# St. Lucie Unit 2

## NRC Update SL2-13 November 2001 Steam Generator Inspection Plans

STEAM GENERATOR TUBE INSPECTION DISCUSSION POINTS  
 PREPARED BY THE OFFICE OF NUCLEAR REACTOR REGULATION  
 FLORIDA POWER AND LIGHT COMPANY  
 ST. LUCIE PLANT, UNIT 2  
 DOCKET NO. 50-389

STEAM GENERATOR TUBE INSPECTION DISCUSSION POINTS  
PREPARED BY THE OFFICE OF NUCLEAR REACTOR REGULATION  
FLORIDA POWER AND LIGHT COMPANY  
ST. LUCIE PLANT, UNIT 2  
DOCKET NO. 50-389

5

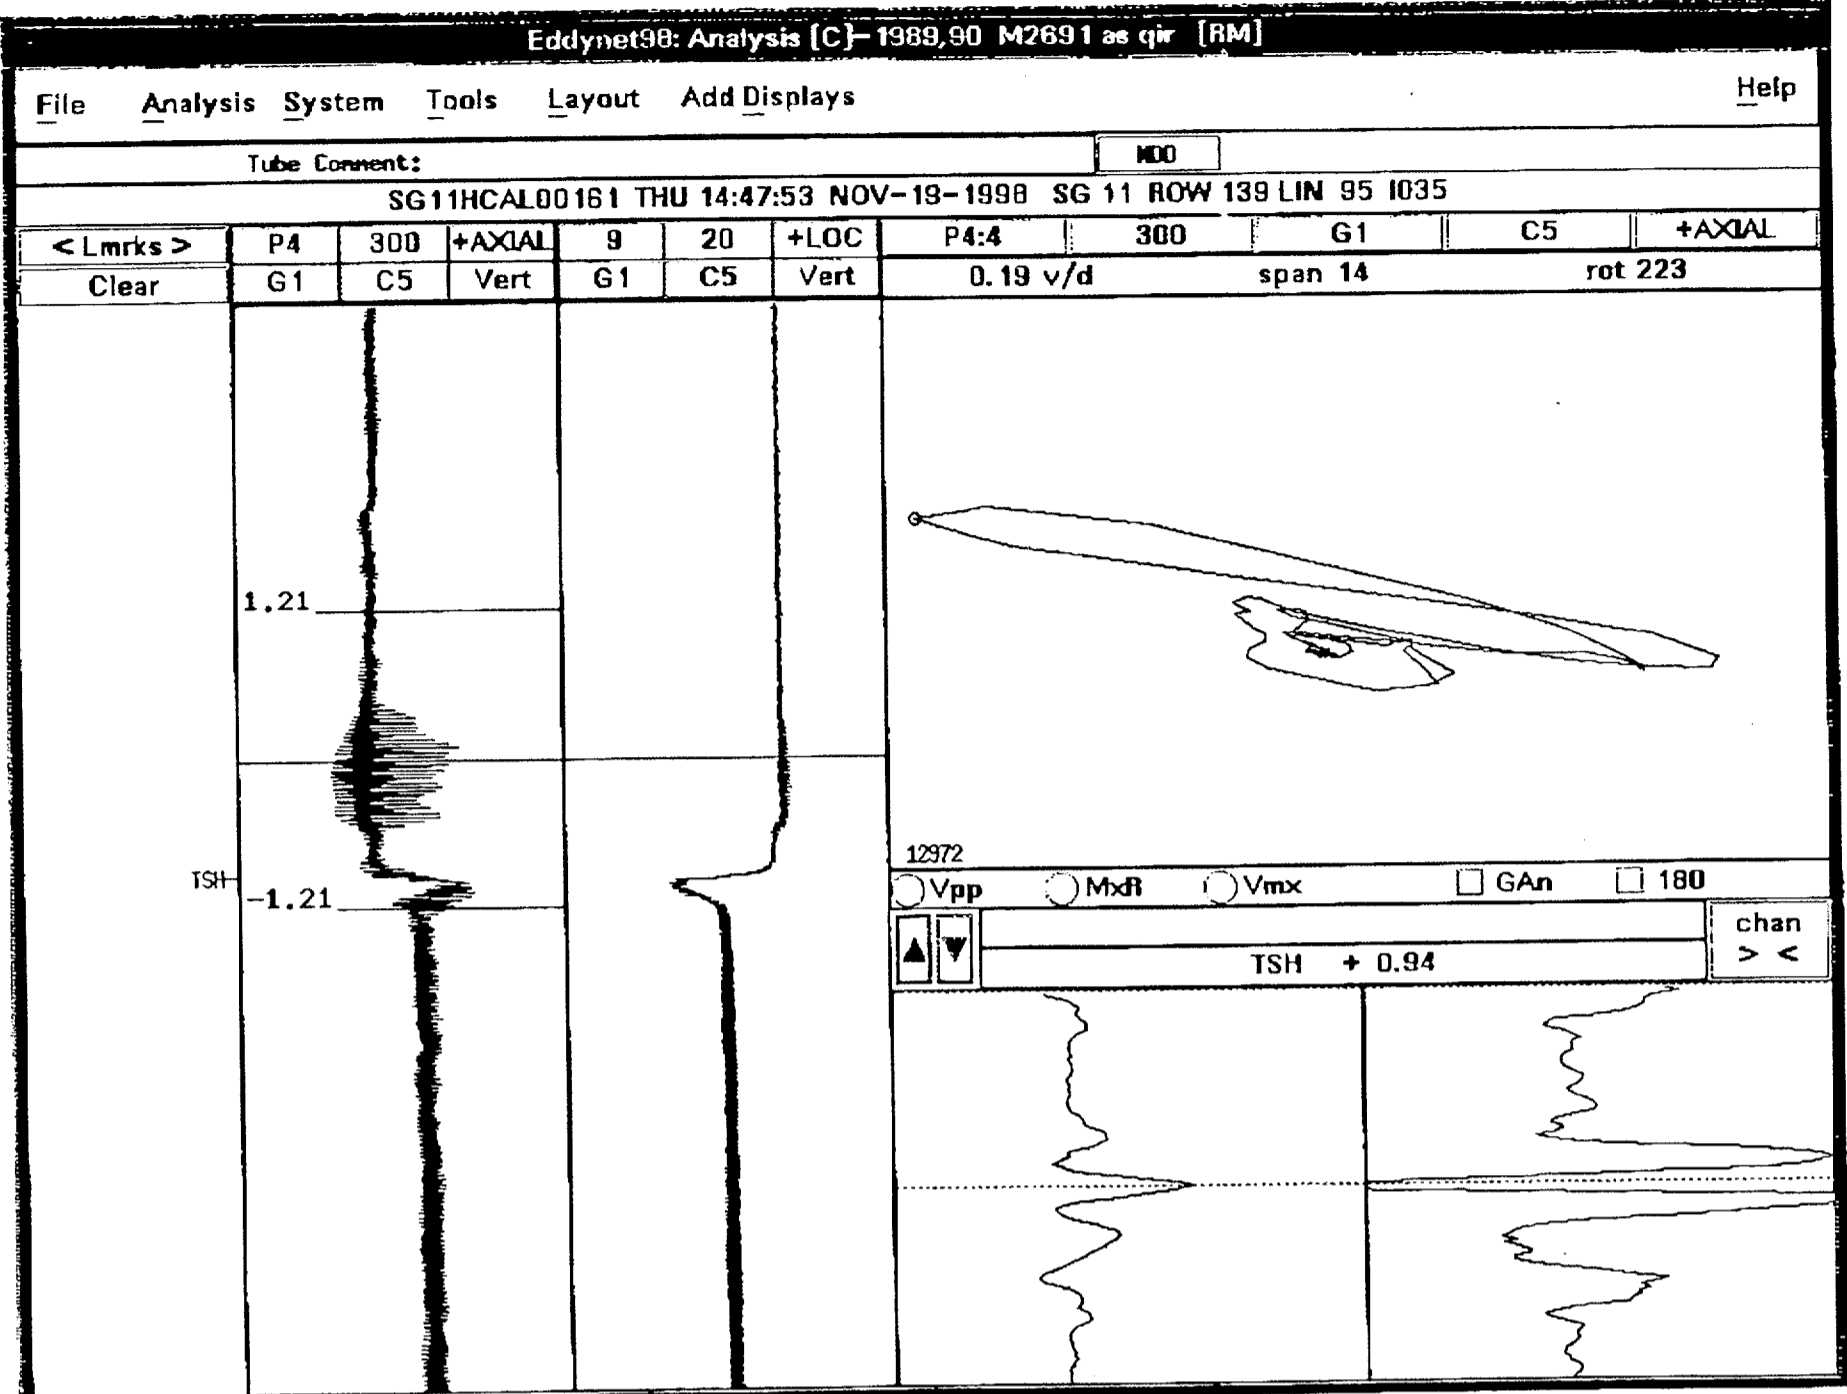
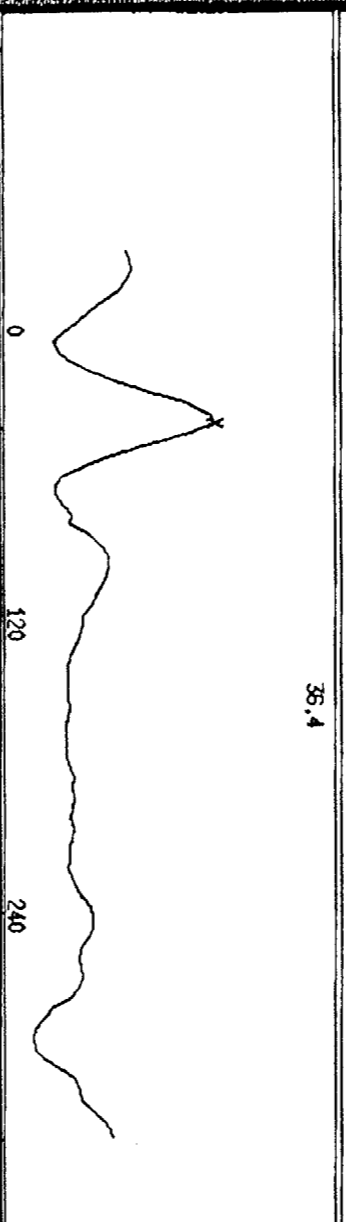
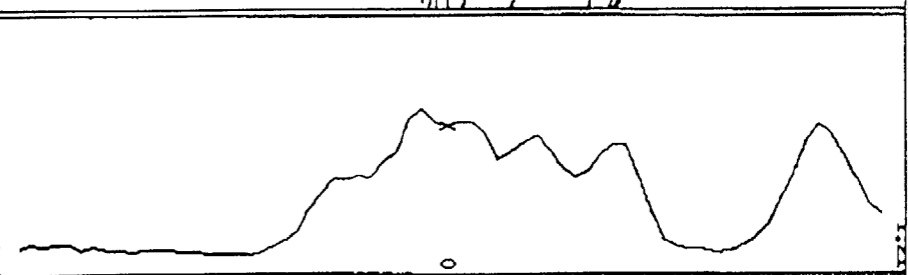
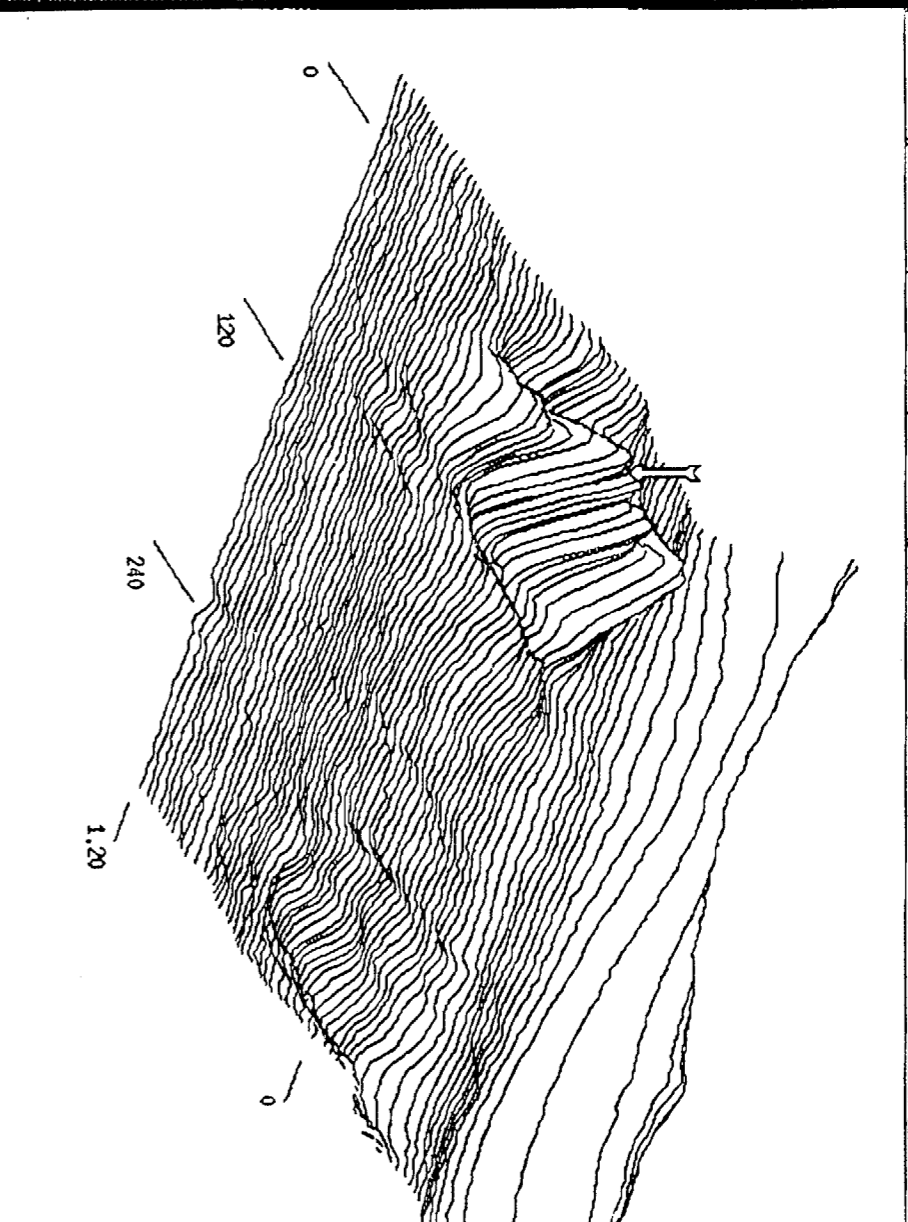
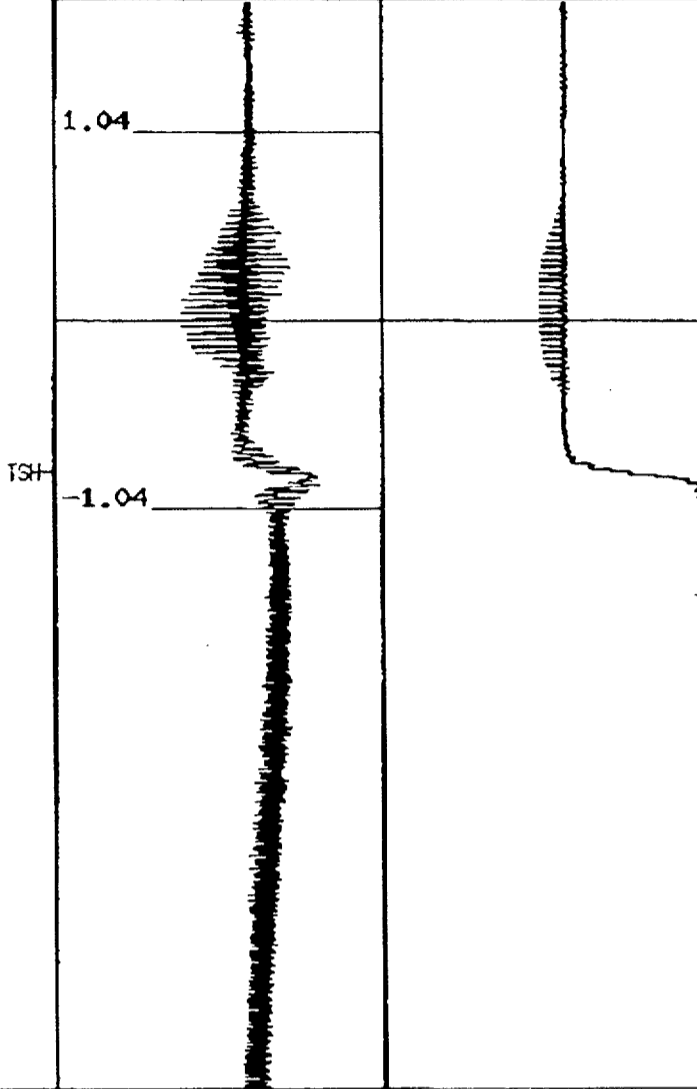
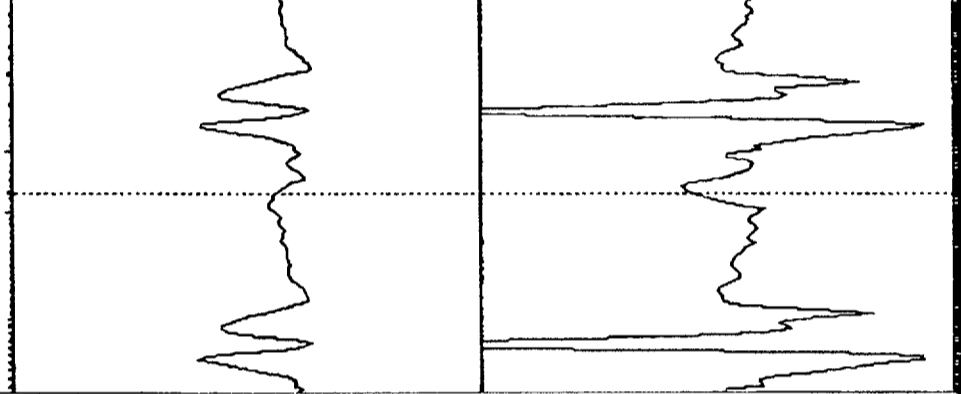
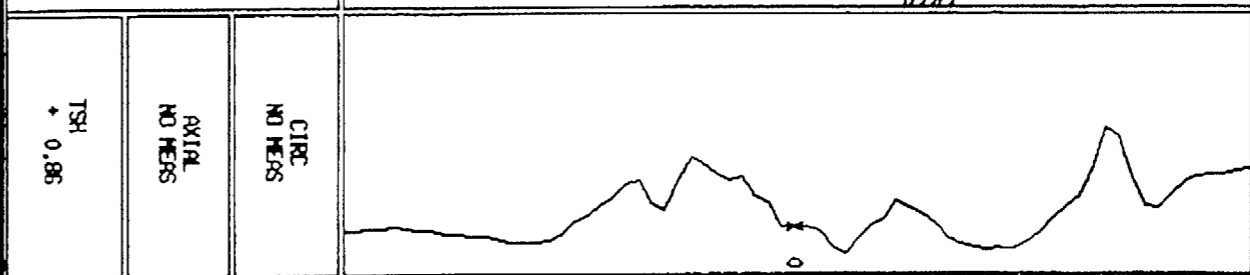
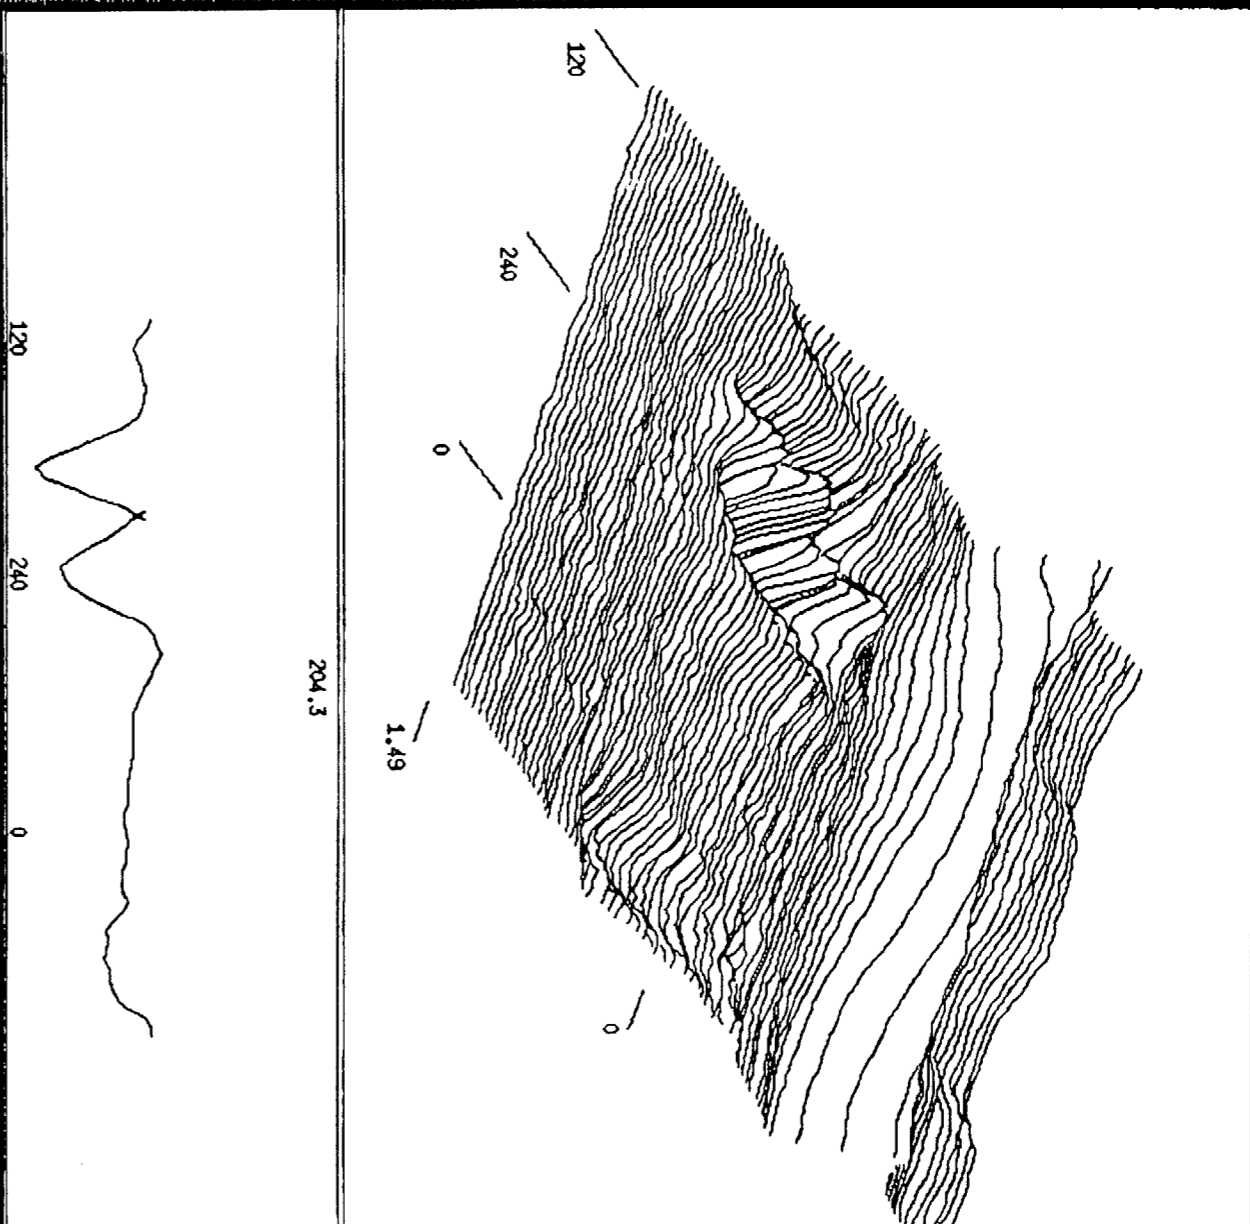
**Issue 1:** Provide eddy current graphics and discuss the evolution of the worst indications detected in dents (See Attachment 1 – 13 Pages).
